AMEREN/UE
DOCUMENT CONTROL SYSTEM
DOCUMENT TRANSMITTAL

TEMPORARY CHANGE NOTICE REQUEST FORM

TCN NO. 00-0231

PROCEDURE TITLE Emergency Operations Facility Operations

NOTIFICATION FLOWCHART

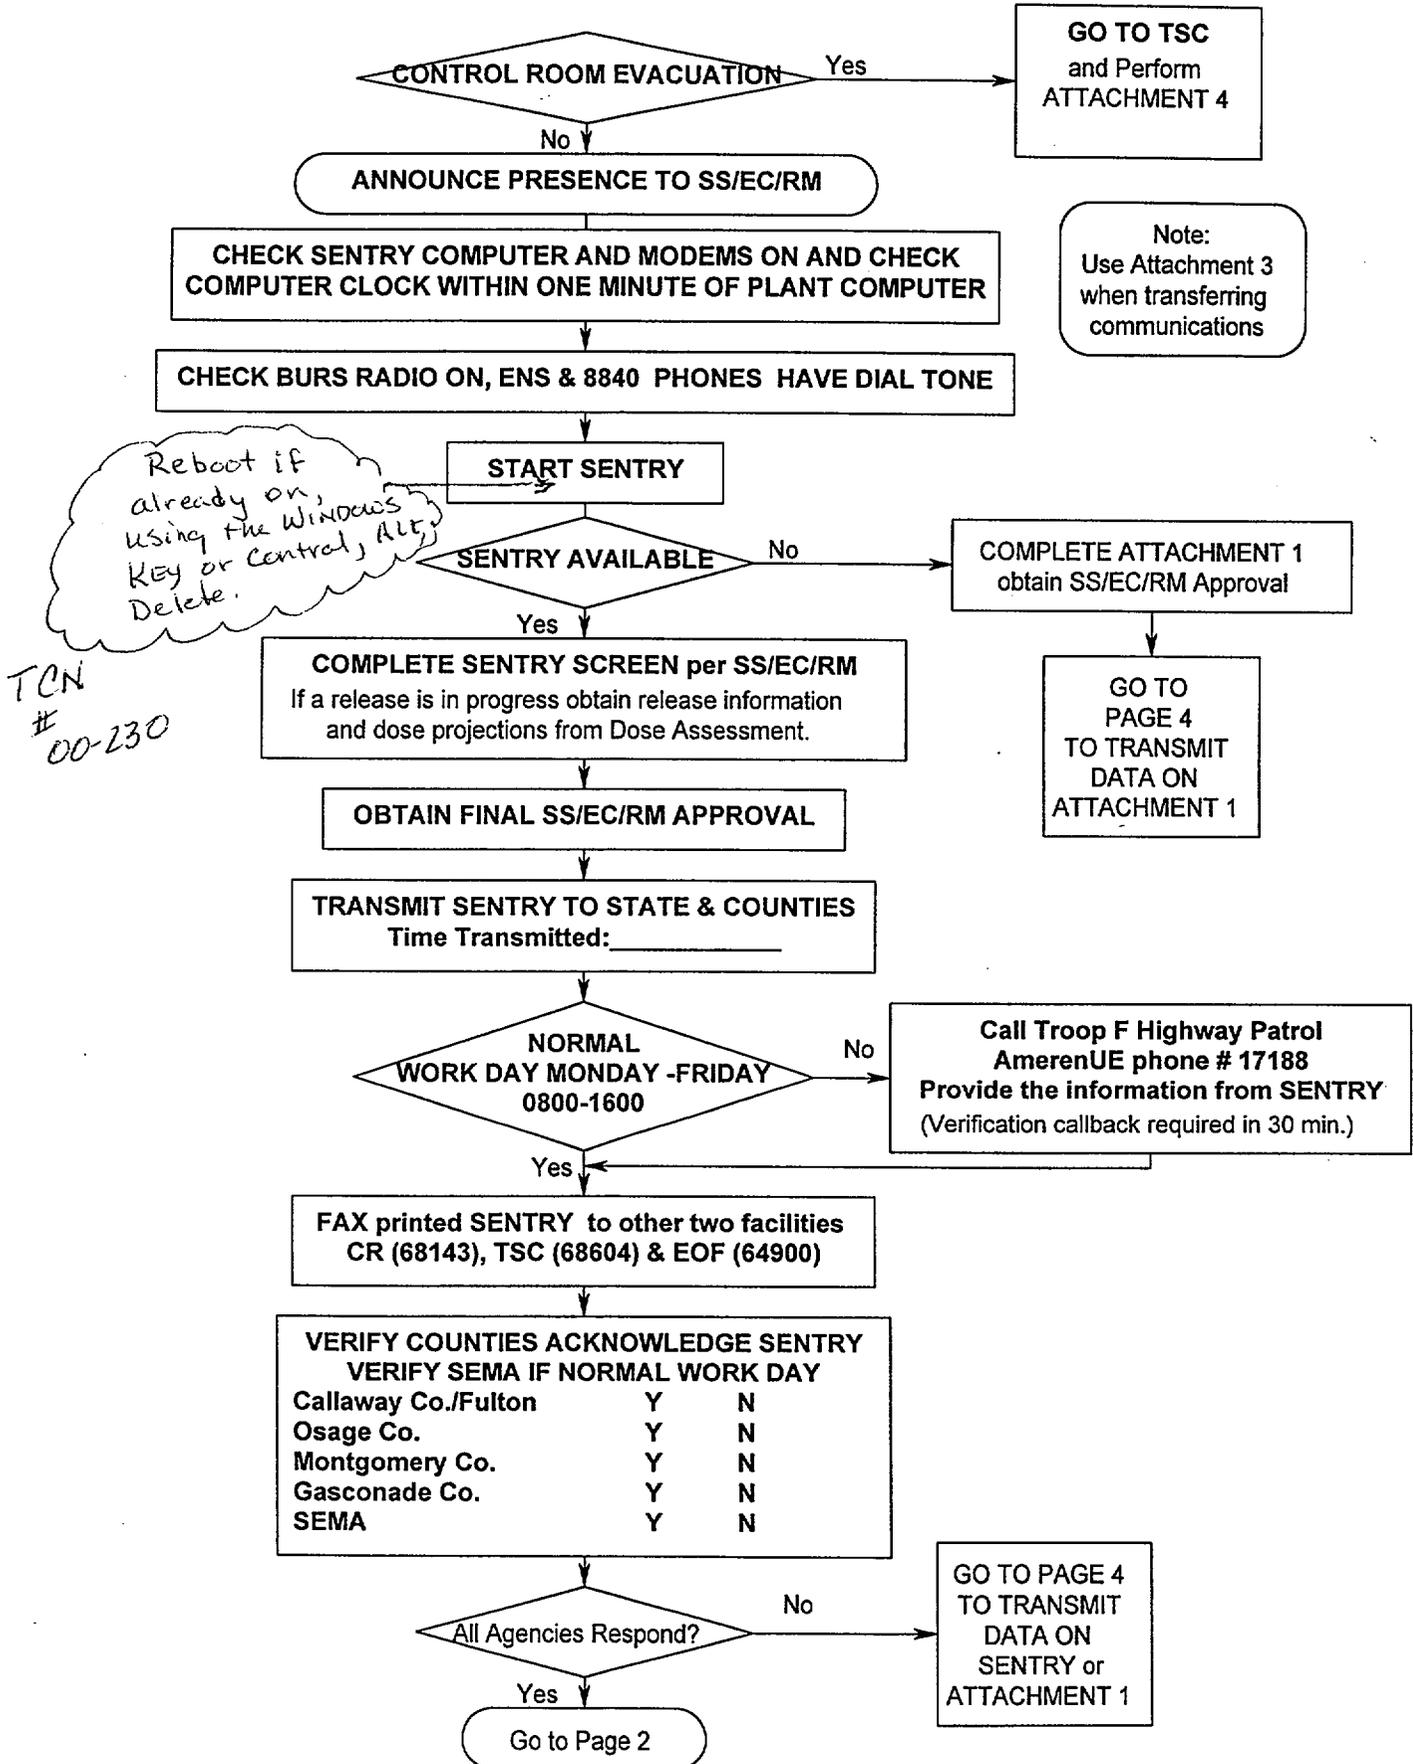
2.1 PAGE NUMBERS AFFECTED BY CHANGE Page 4, step 4.1.2.1.1 and Attachment 5, page 1 of 4

2.2 CHANGE SUMMARY Instructs the user to reboot the SENTRY Computer prior to use if it is on. The SENTRY Computers are normally left on now to allow a midnight diagnostics check to automatically be performed. In order to refresh the computer a reboot is now required.

Reboot if
already on,
using the Windows
Key or Control, ALT,
Delete.

TCN
00-230
